Re: RZ/FDP 2005-SP-019, Ridgewood, (Tax Map 56-2 ((1)) 37): Site Modifications

RE: Proffer Interpretation for Rezoning RZ 2005-SP-019

CONCEPTUAL GARAGE
COURTYARD ELEVATION

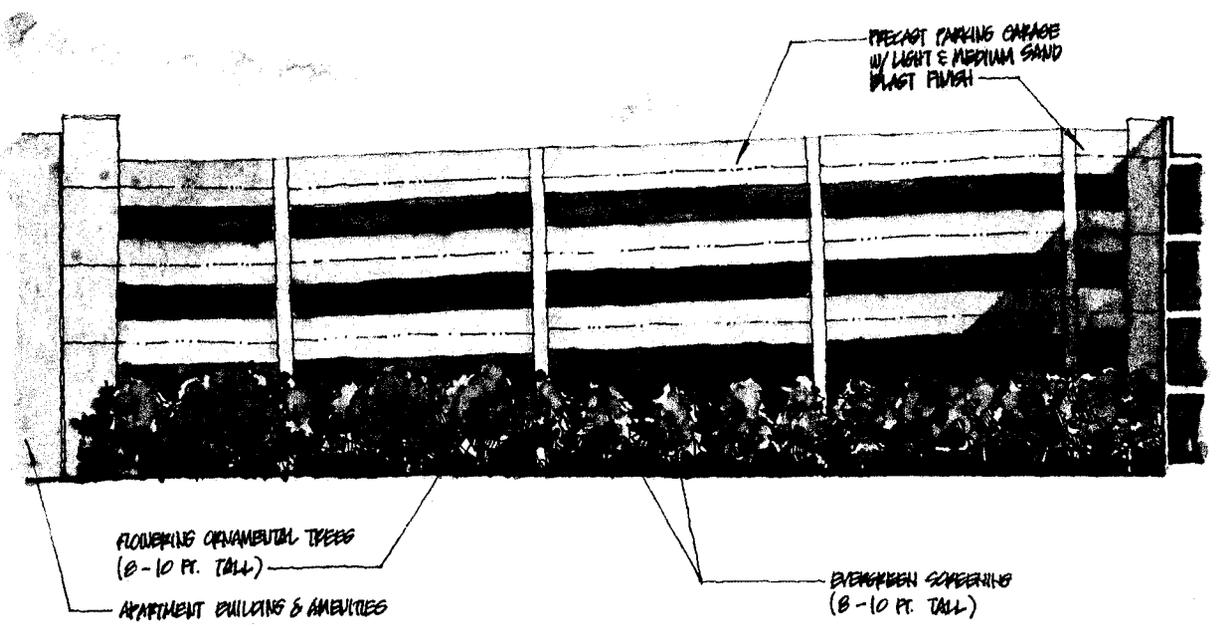
This is a follow-up to my earlier letters on the same subject. In our most recent conversation, you have asked for some additional information about the architectural and design treatment of the portions of the parking garage that are visible within the interior courtyards associated with "Building 3".

To that end, attached is a sketch showing design commitments that reflect this objective. Their comments go well beyond the obligations of the proffers. The proposed design incorporates an aggressive landscaping proposal at ground level. In fact, proposed trees closest to the garage will be 8-10" in height at the time of planting. In addition, the Applicant has committed to design the visible portions of the garage with a color and texture of materials that is complimentary to the building facade.

5 BUILDING 2 COURTYARD
1"=20'

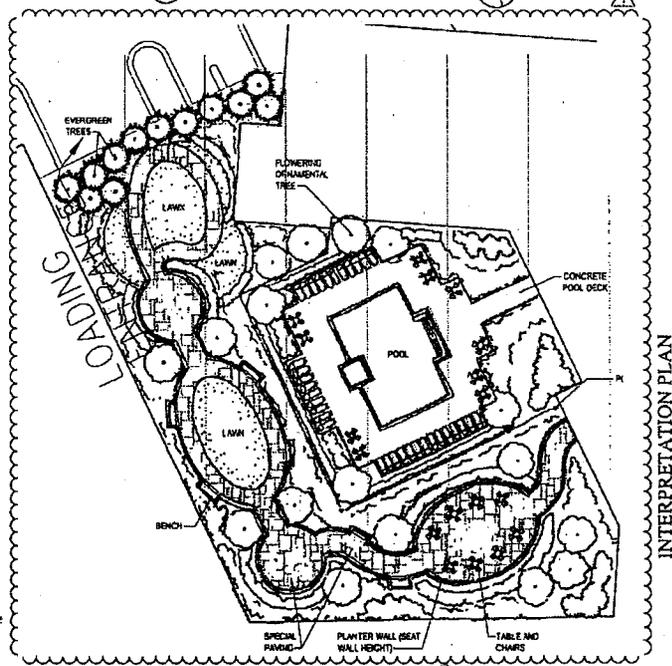
Similarly, the plaza at the southeast corner of Building 2.2 has also been reconfigured to provide a general shape and usable area that is clearly in substantial conformance with the CDP/FDP. For ease of reference, I have attached several colored exhibits (Exhibit 3) that comparatively show the current proposed plaza in

relation to that reflected on the CDP/FDP. While it is true that final building design has caused a very minor reduction in the actual size, this reduction only comes at the expense of a narrow triangular portion at the north of the plaza that was largely unusable. The design reflected on the Interpretation Plan retains all of the required decorative and design elements, and actually has a depth that is slightly greater than that reflected on the CDP/FDP. The current design of this plaza is equally or more usable as compared to that shown on the governing CDP/FDP.

CONCEPTUAL GARAGE
ENTRY ELEVATION

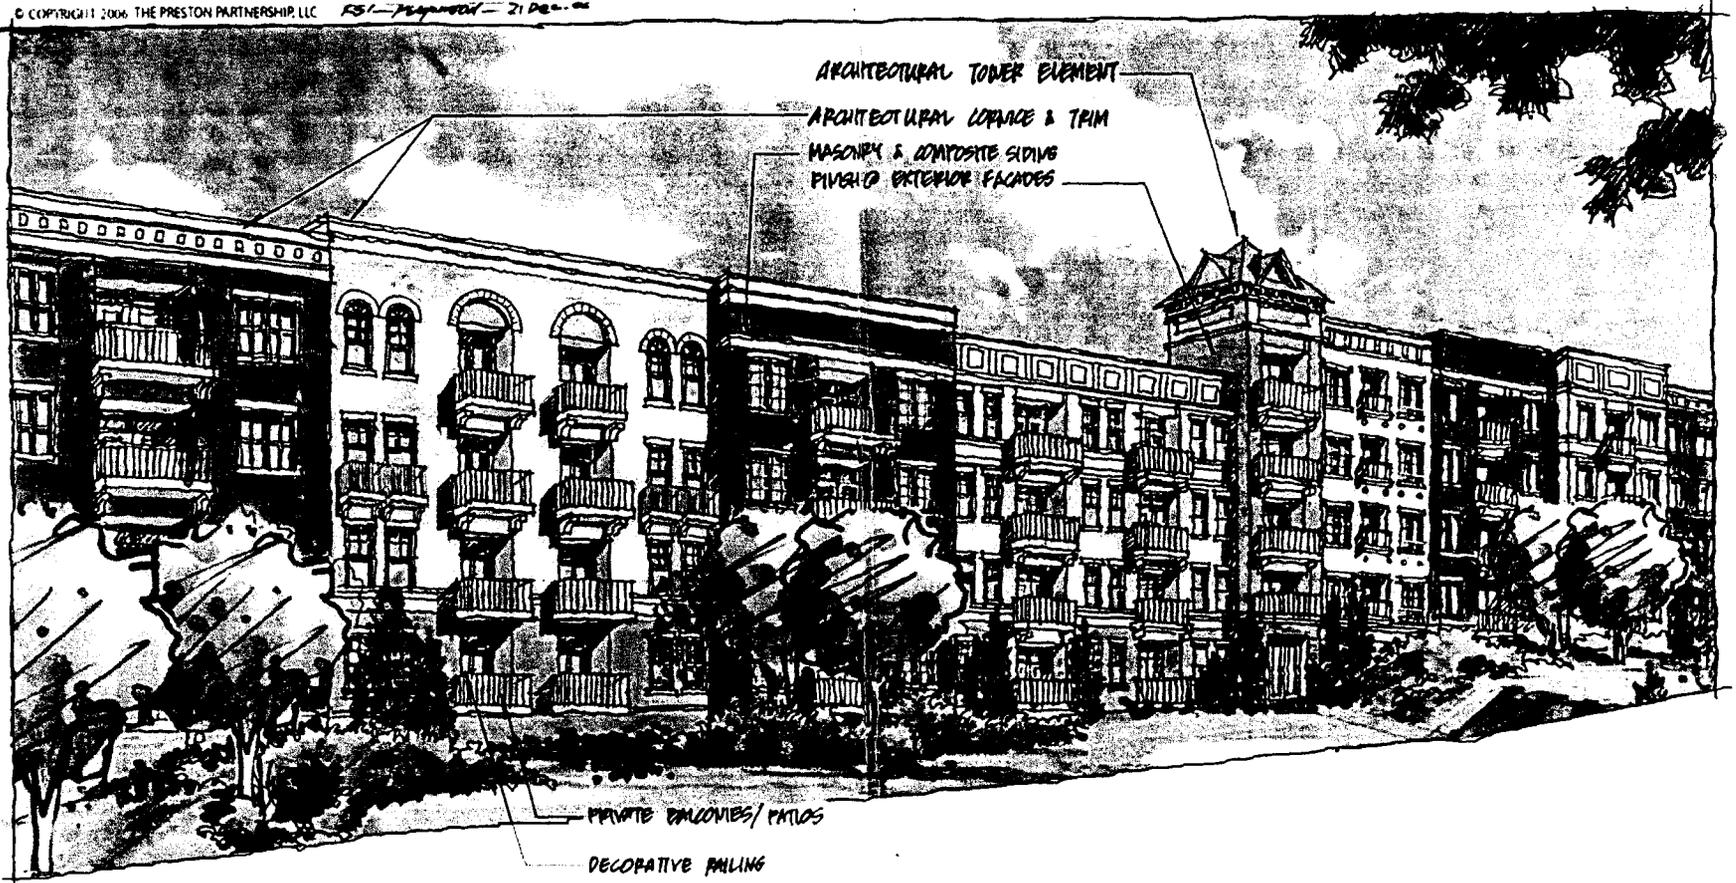
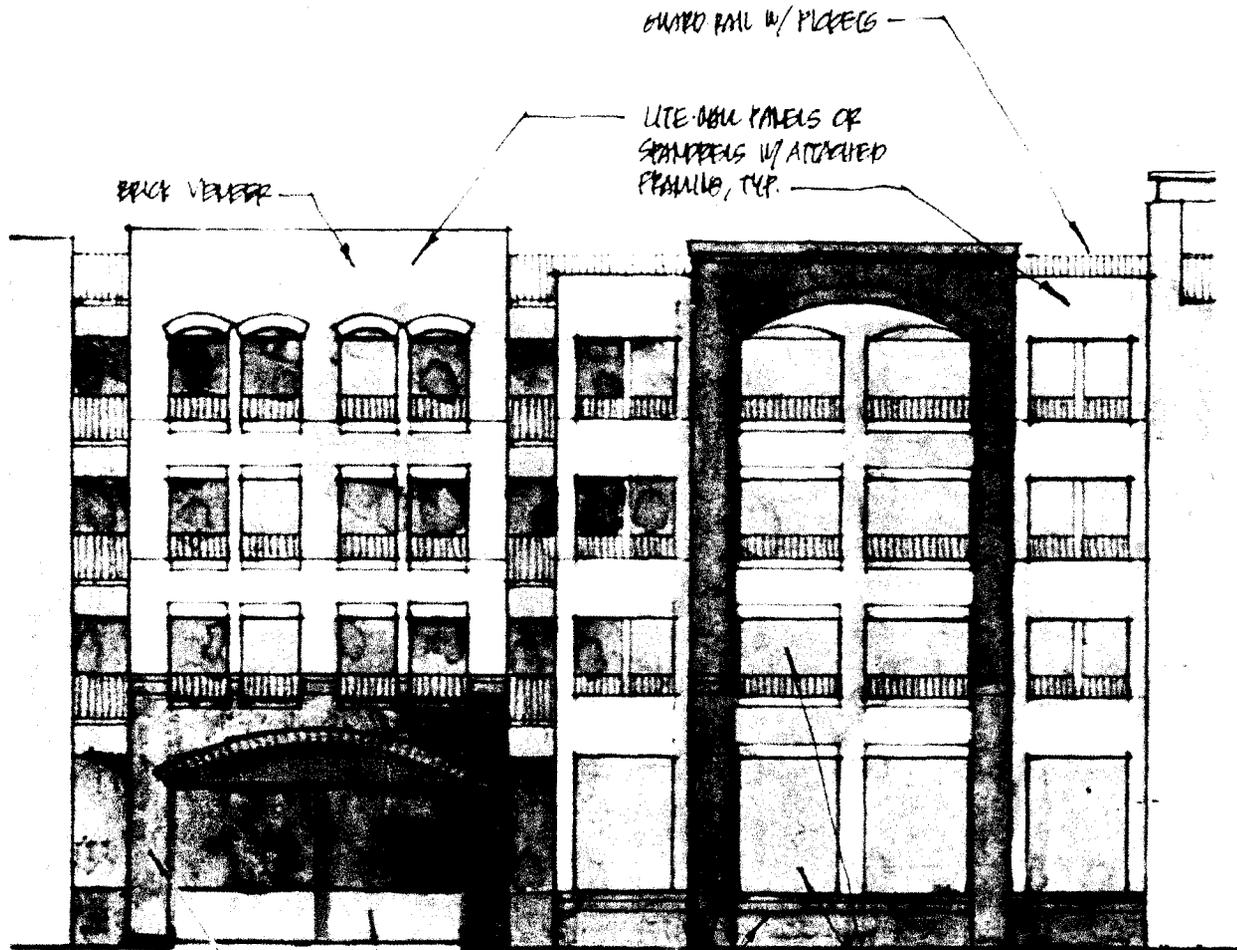
Staff had requested additional design detail regarding the appearance of the parking garage entrance now proposed from the internal east-west roadway. Exhibit 4 contains a detailed rendering that shows the articulation, the design theme and building materials associated with this area of the property. As the Exhibit shows, the developer has gone to great lengths to make the entrance for the garage fully integrated, with the overall architectural scheme. This is a level of design detail well above the minimum requirements of the proffered conditions. As alluded to in our original interpretation request, the practical effect of this minor relocation of the garage entrance is to eliminate a large portion of the exposed parking garage that would have been visible from future development plan on the abutting property to the east.

2 BUILDING 3 COURTYARD SHADOW STUDY

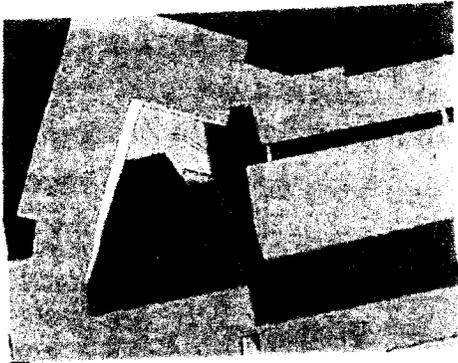
Staff had also asked for reconfirmation that the reconfigured interior plaza courtyard for Building 3 did not diminish exposure of these areas to natural light when compared to that shown on CDP/FDP. Obviously, the proposed minor modification

creates considerably more usable interior recreation space. As to the question asked, there is no diminishment of available natural light. When compared to the governing CDP/FDP, building heights and configurations are not dramatically changed from the governing CDP/FDP. In fact, if anything, the interpretation plans strategically relocates the swimming pool to an area that has even greater exposure to sunlight. Similarly, as further evidence of the visibility of this area, the developer also contemplates the installation of an internal balcony to give residents further access to this area. For ease of reference, I have attached the shadow studies (Exhibit 6) conducted as part of the rezoning approval. Again, given that the height and configuration of the building is not changing in the relevant areas, these studies remain effective in terms of evaluating the presence of natural light.
